SITE PLAN

92 Arthur Street

Site Plan File # SP11-024  
82 Arthur Street South, Guelph, Ontario

92 ARTHUR ST - Site Plan 1  
Scale: 1 : 200 SP.01

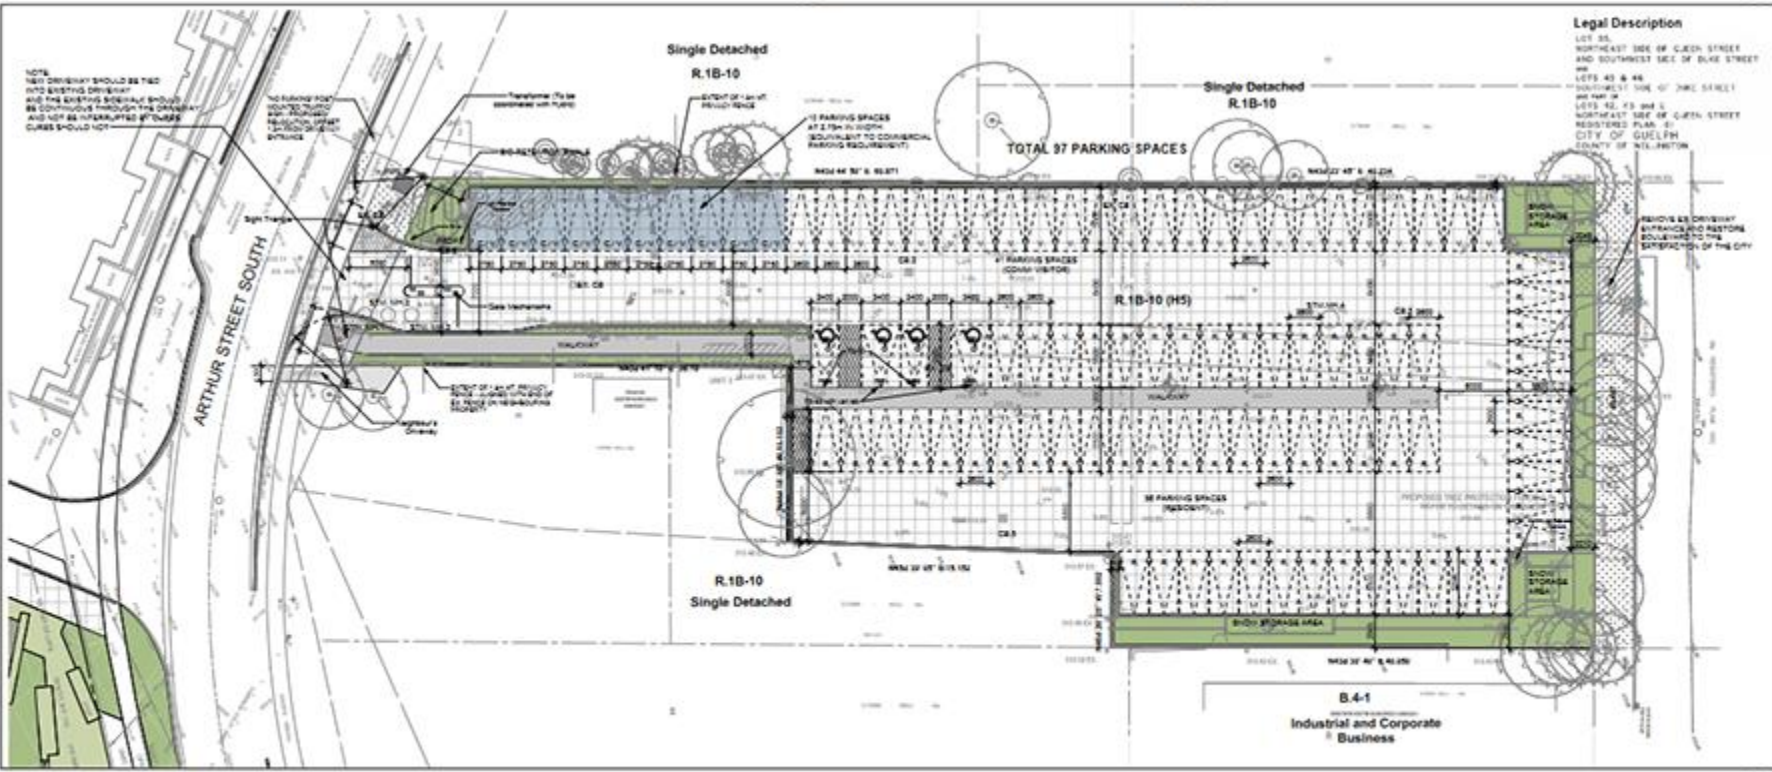
<p>elevation (abutting MW3). Question raised regarding length of building.</p>	<p>on-site parking.</p> <p>The podium facades have been further detailed through the SPA process. To reduce the visual impact of the parking structure, glazing will be incorporated into the facades to introduce natural light into the parking area. Further, ivy will be planted along the edges to create screening along Cross Street. The design of the building, including the façade of the parking structure, has been reviewed by both City staff and the Urban Design Peer Review Architect.</p>
<p><b>Off-site Parking (92 Arthur Street South)</b>  Questions were raised regarding the short and long-term ownership of the parking area and whether the parking area would be designed to align with the overall aesthetic of the Metalworks development, including enhanced landscaping.</p> <p>A delegation noted that there is a green space connection proposed through the Site within the Downtown Secondary Plan.</p>	<p>Fusion Homes has confirmed that the parking lot at 92 Arthur Street South will be owned by the condominium corporation of MW4. The condominium corporation will be responsible for the long-term maintenance of the parking lot and to manage the parking spaces and will retain the revenue from the pay-per-parking spaces available to the public.</p>
